SSDA REPORT

North Sydney Public School 182 Pacific Highway, North Sydney NSW 2060

Report Prepared for: Department of Education
Report Prepared by: Lucy Alderson
Our Ref: AN021-216878 SINSW
Date: 27 August 2021

1 SECTION
BUILDING J - SECTION
SCALE: 1:100

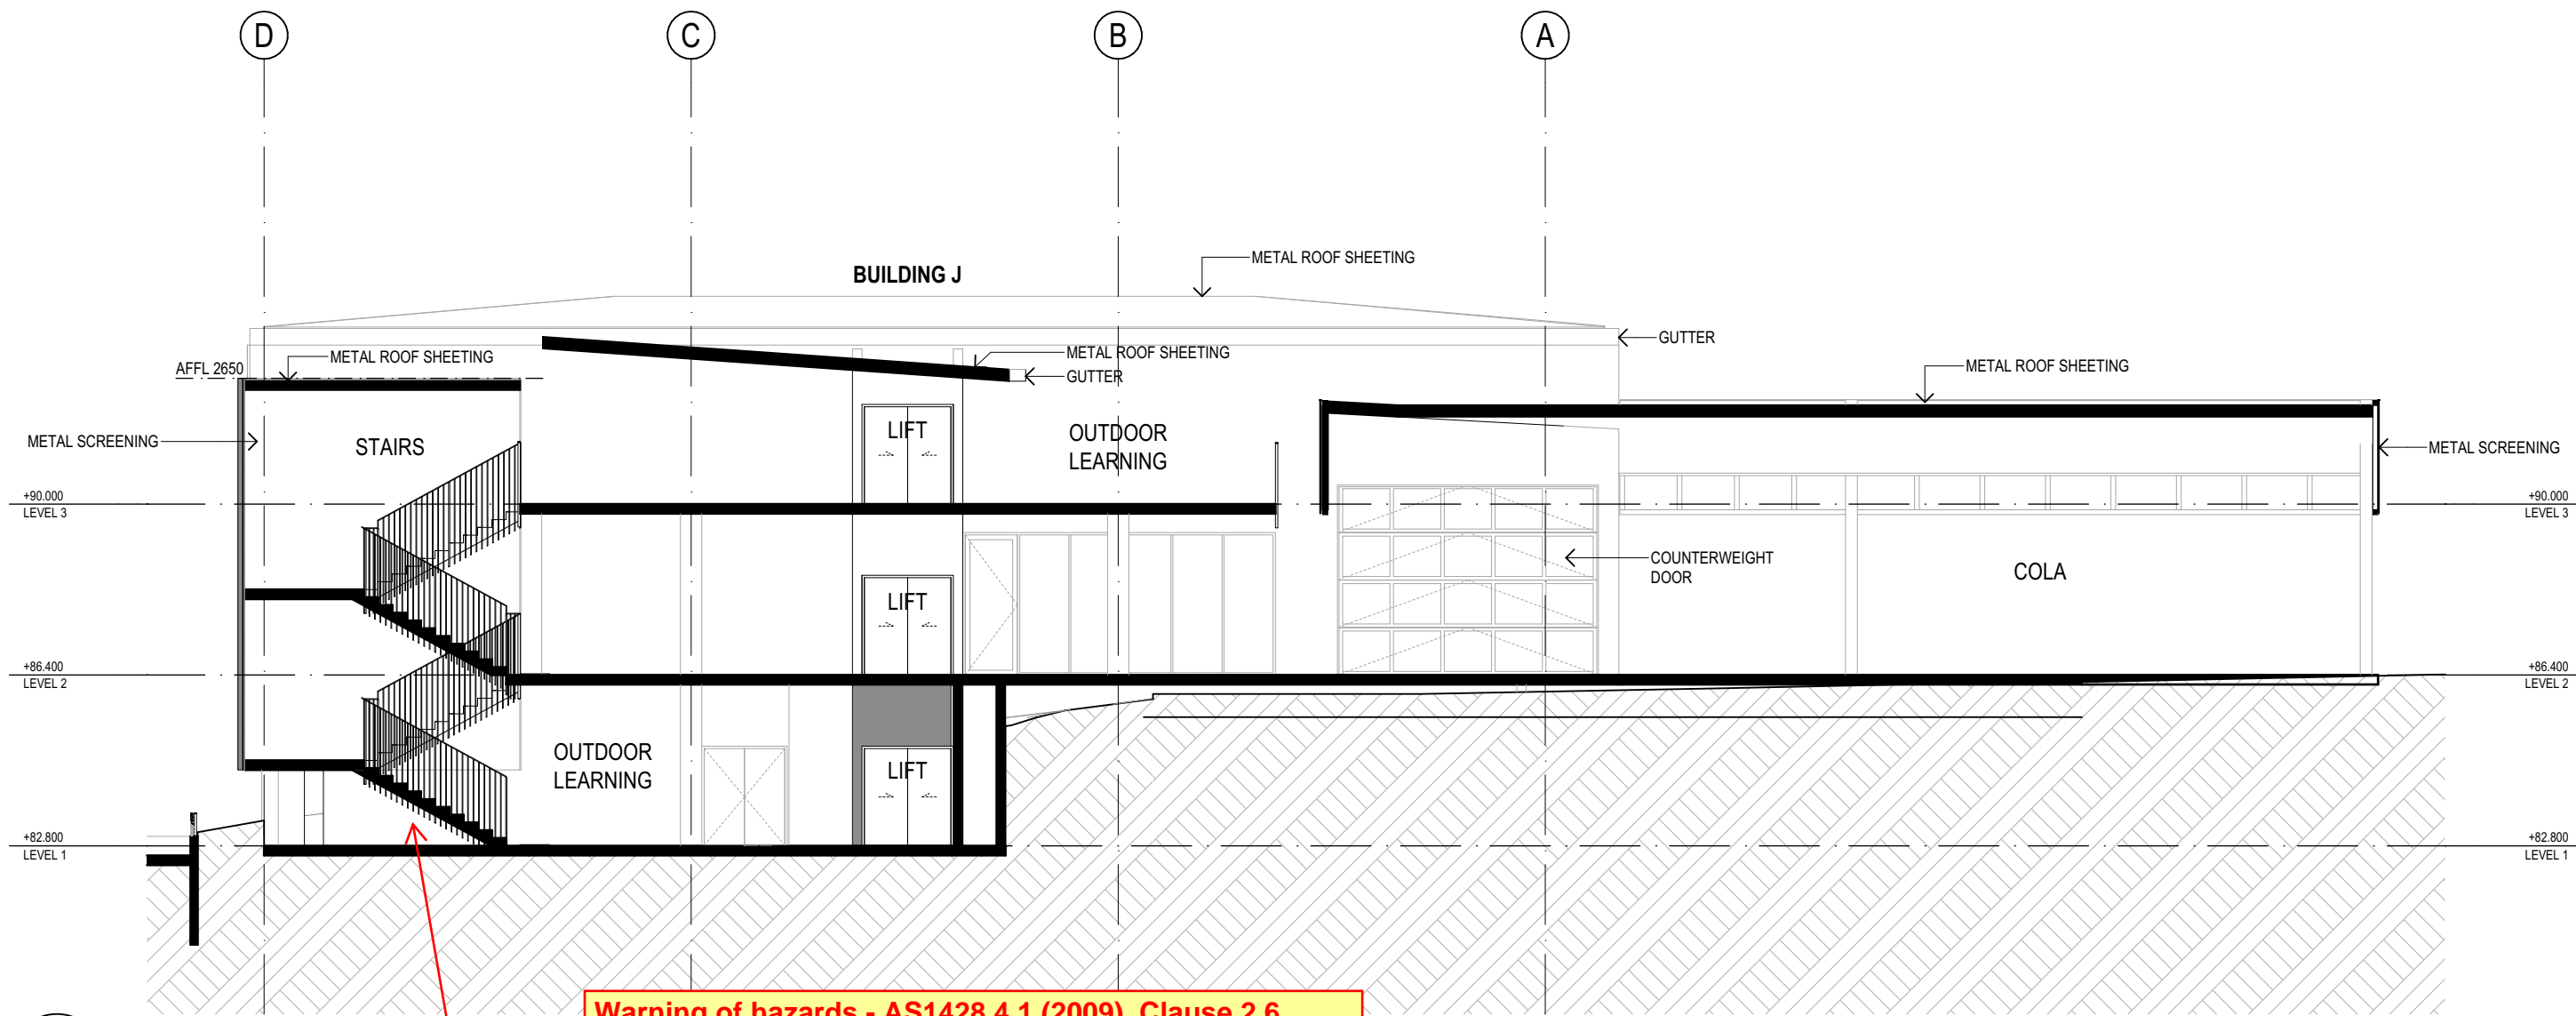
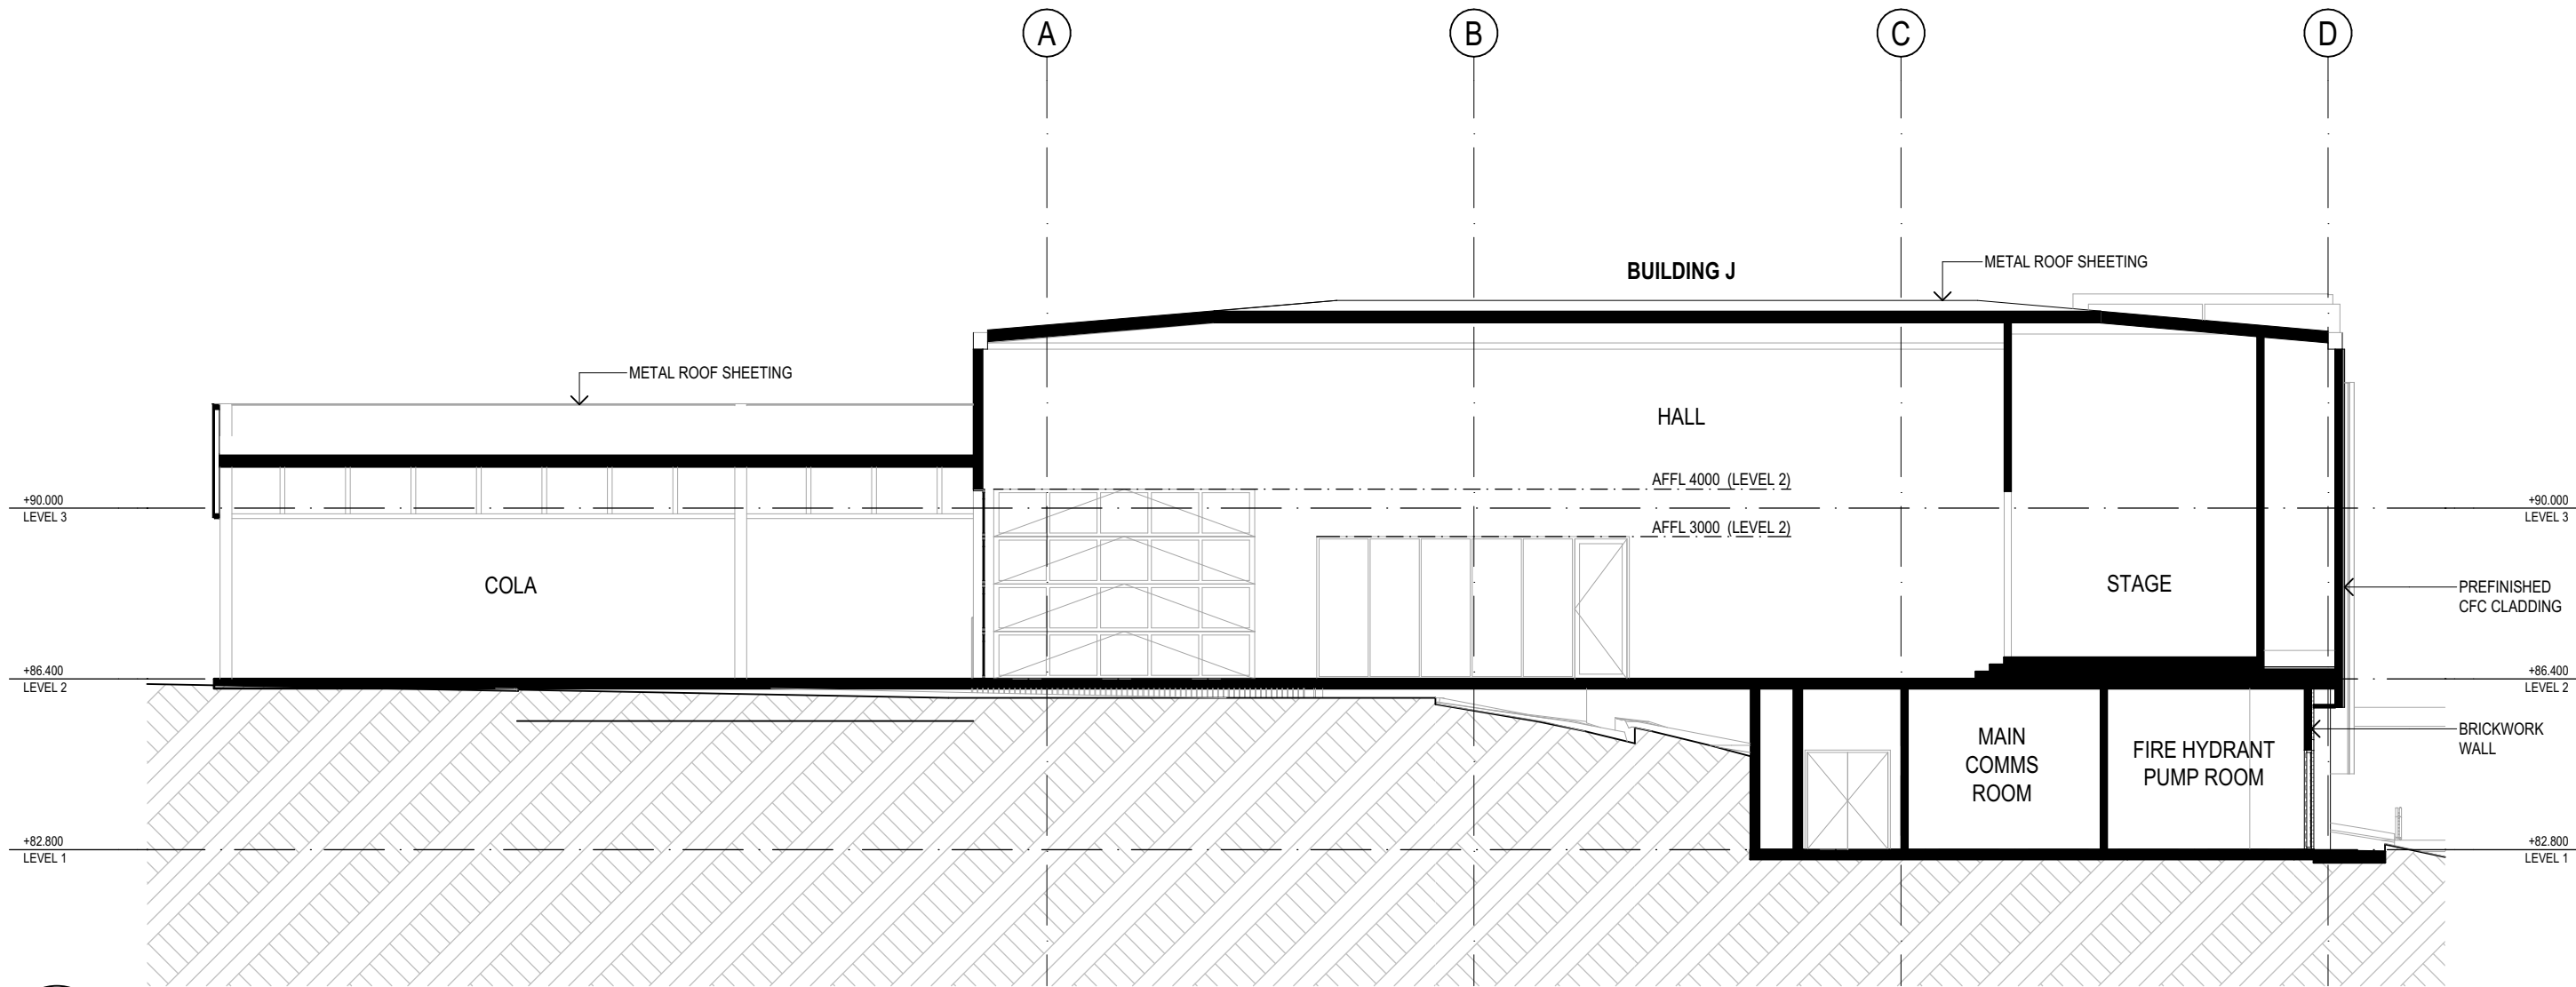
Warning of hazards - AS1428.4.1 (2009), Clause 2.6
Possible overhead hazard below the stairs.
Where there are impediments or hazards with less than 2000mm height clearance in an accessible open public space with no clearly defined continuous accessible path of travel, contact with overhead hazard shall be prevented by a suitable barrier complying with AS/NZS 1428.4.1 (2009), Clause 2.6(a)(b) and Figure 2.6(A)(B).
